# EDCP Questions

Bob Sultan ([bsultan@huawei.com](mailto:bsultan@huawei.com))

Figure 41-1—Example EVB TLV exchange

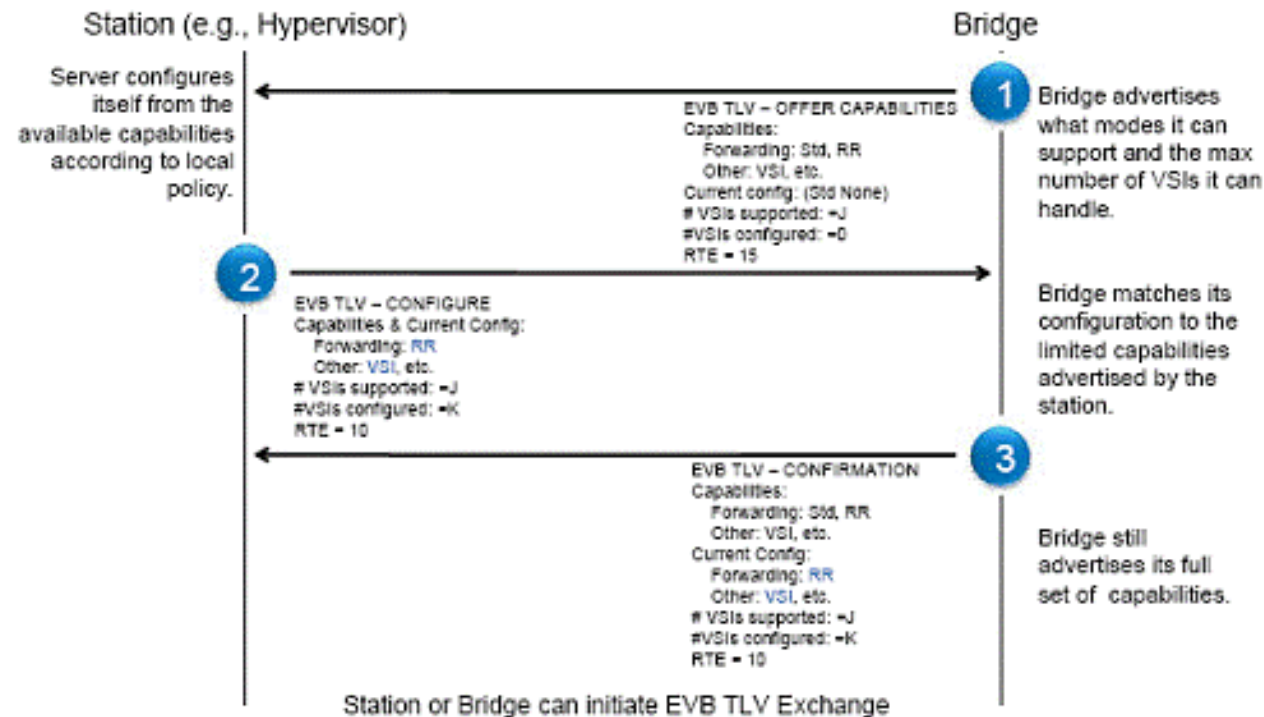
- In which case, this picture is modified as there is *no* 'offer', 'configure', 'confirmation';
- Just EVB TLVs sent periodically and *independently* in both directions;

- Thus, there is never a ‘negotiation’ between the two sides;
- Each side looks at a received value and its own value and has an algorithm to make a decision solely on that basis;
  - should that algorithm be specified apart from the TLV description
